**PHILADELPHIA INTERNATIONAL AIRPORT
SACRIFICIAL SLABS PHASE 2**

**Amendment No. 1
Bid No. 6502**

**Dated: September 11, 2019
Bid Opening Date: September 26, 2019**

Project No.: PHL-1901.24

Permit Fees

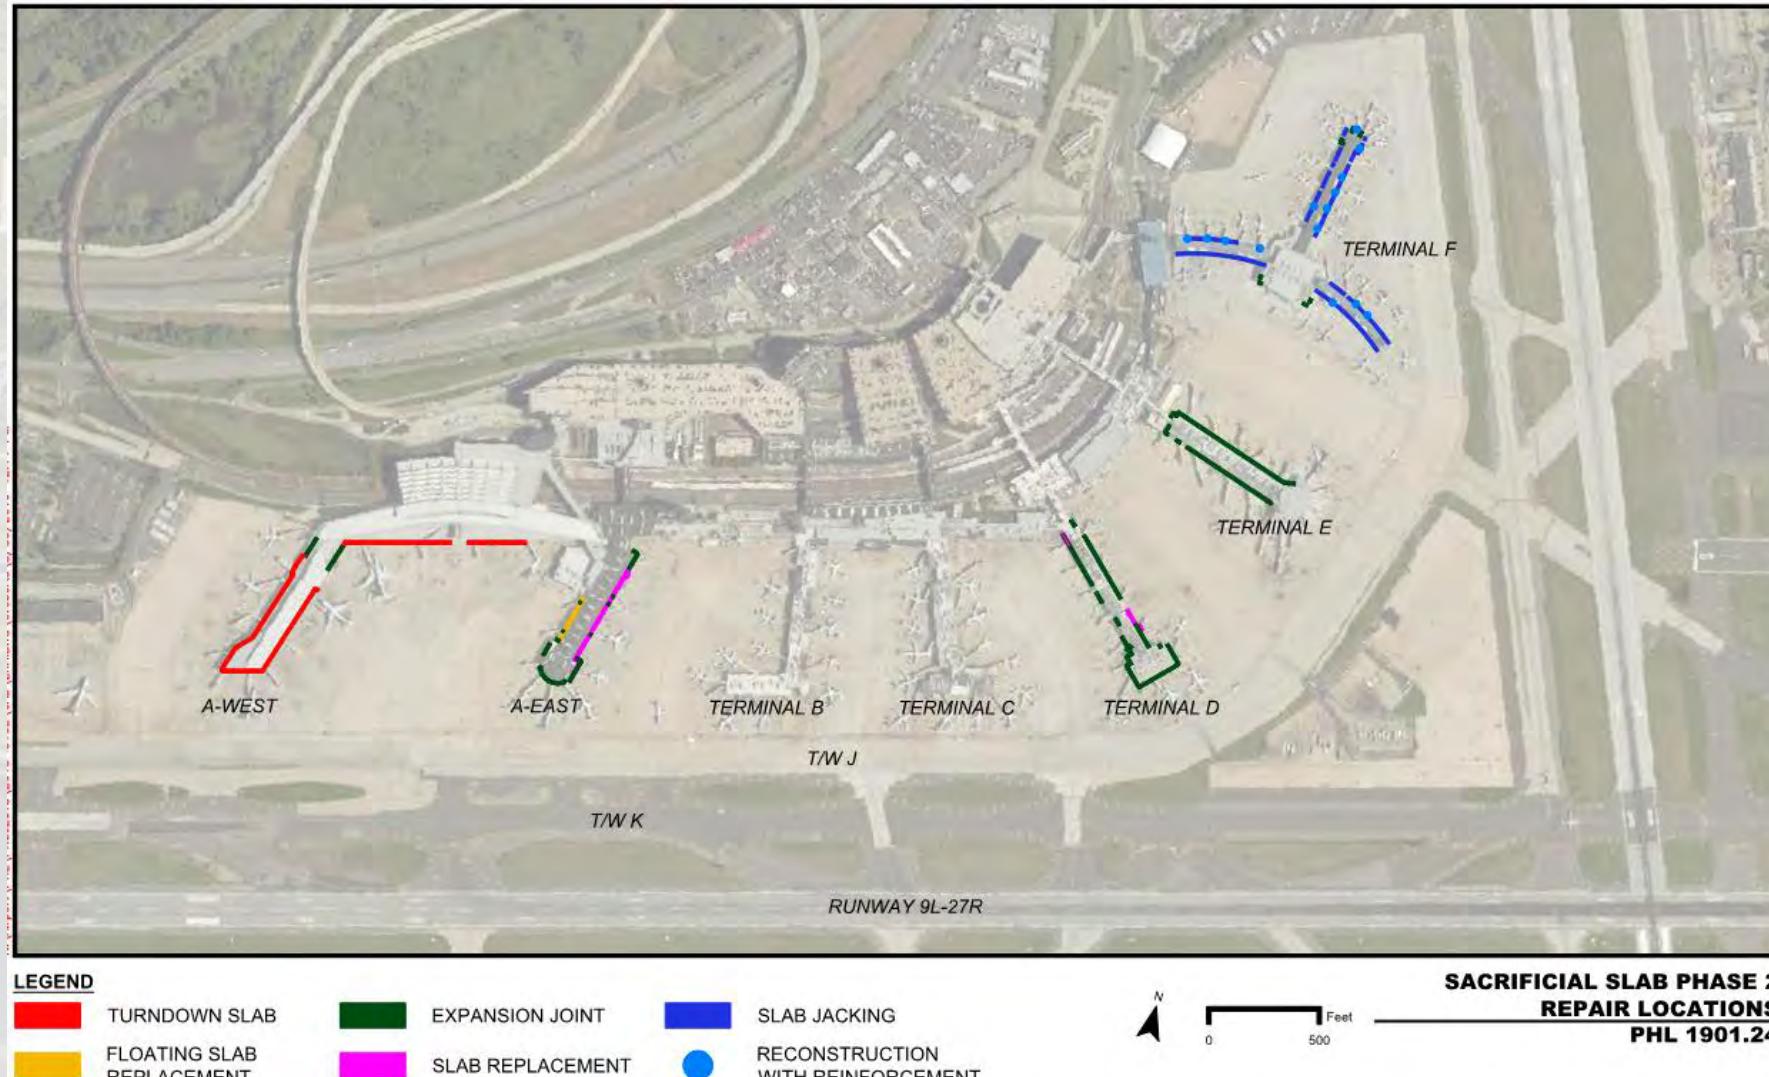
- Contractor shall confirm with local jurisdiction which permits are required prior to bidding
- Design team is going to review permitting with DOA as this is a maintenance project, perhaps it will not apply.
- It was noted that permits may be required per terminal. DOA to review this requirement and any required changes will be issued via future amendment.

- Tinicum Township – for the work done in Tinicum Township
- For Tinicum Township permit and miscellaneous questions – Antoinette Meindl (610) 521-3530

Slab Jacking Repair

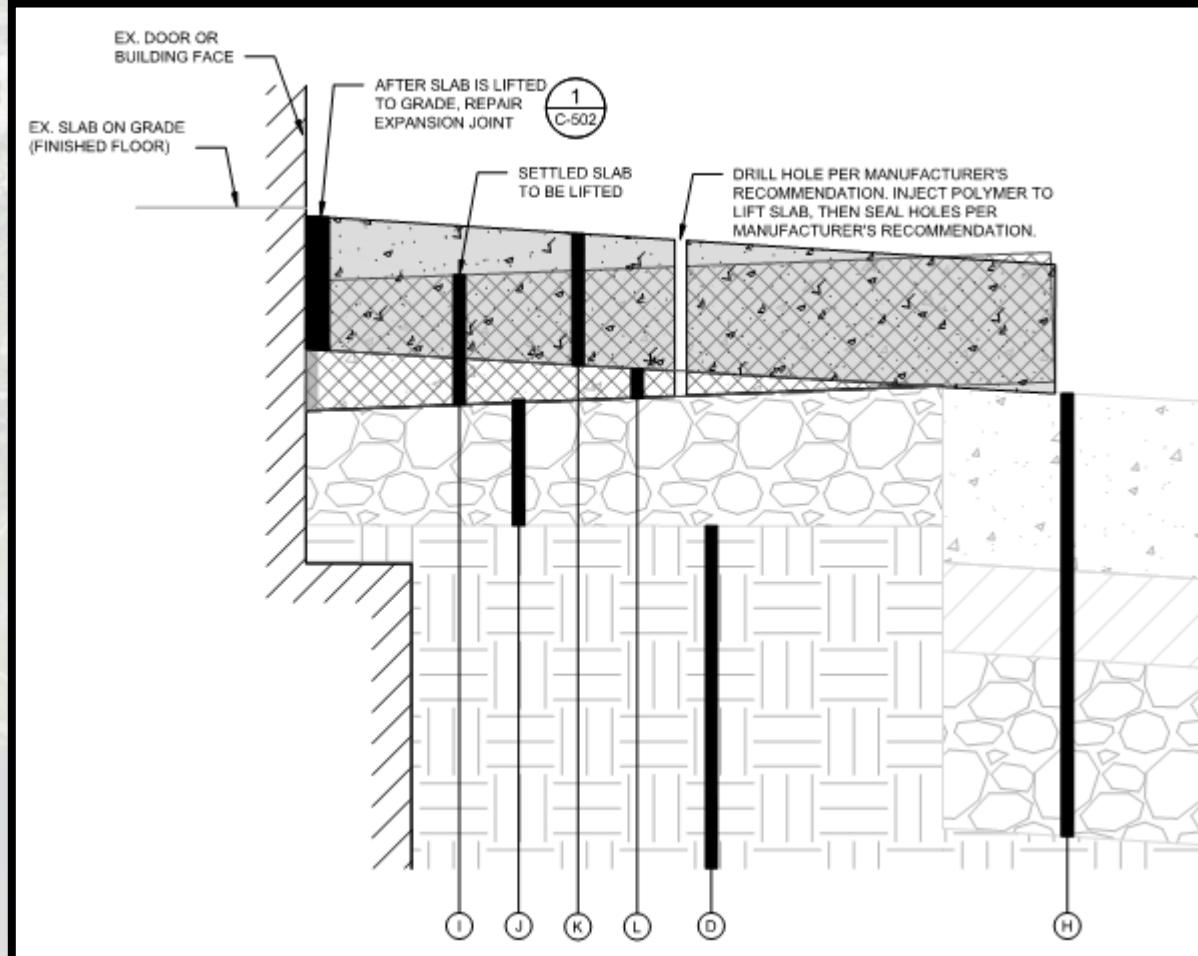
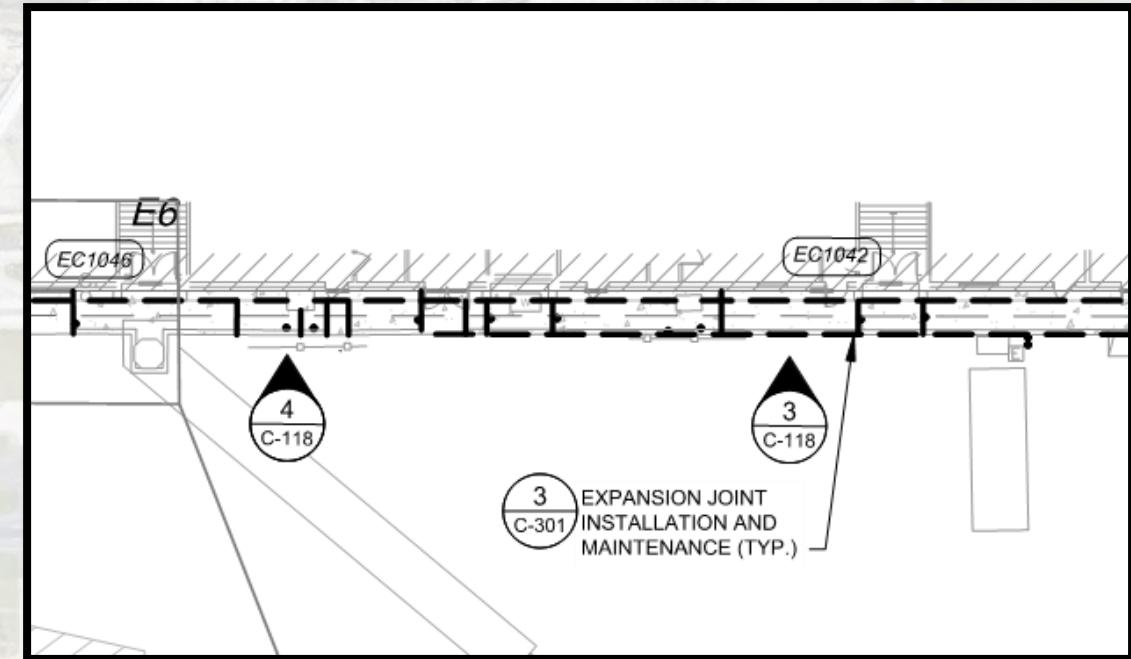
- Any slab jacking will require monitoring by the contractor and jacking will be discontinued if adjacent pavements are noted to be moving.
- It was noted there are conduits mounted to the building near terminal F, the contractor inquired if this would impact slab jacking. Design team will review and offer any clarifications via amendment.

- It was noted slab jacking is generally measured by the pound of material that passes through the “gun”. Design team to review the specifications and make any required adjustments via future amendment.

Expansion Joint Repair

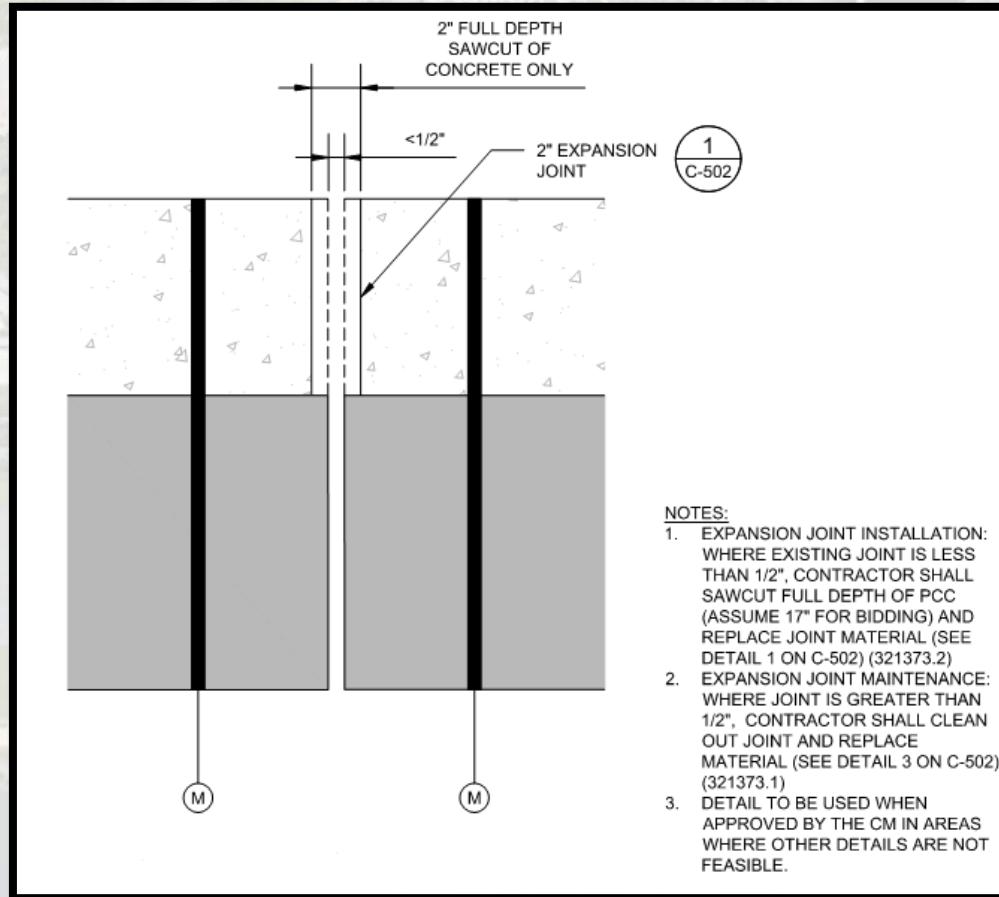
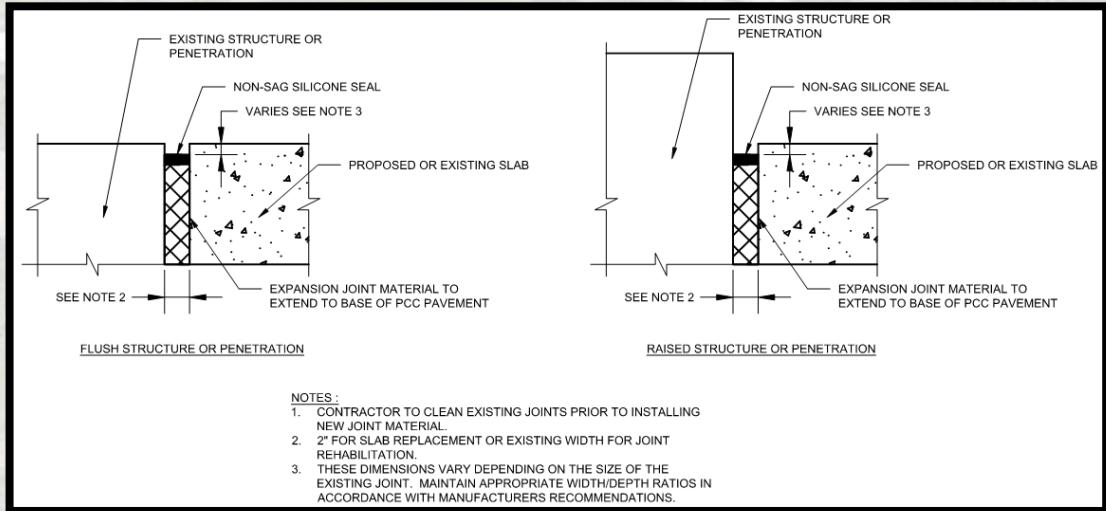
- Contractors suggested Self Leveling over Non-sag or preformed to have cleaner joints. The design team explained the rationale for not using the self-leveling in the larger joints (pre-formed is required) nor using where pedestrians can step into a wider joint. Design team will review plans and offer any clarifications deemed required via a future amendment.

- There are some sealants in the specs that are harder to procure, or that only come in small caulk guns – not practical for this project's quantity. It was noted that the specifications provide several options for sealants in areas where preformed is not required. In the areas requiring preformed sealants, only elastomeric preformed seals will be accepted.
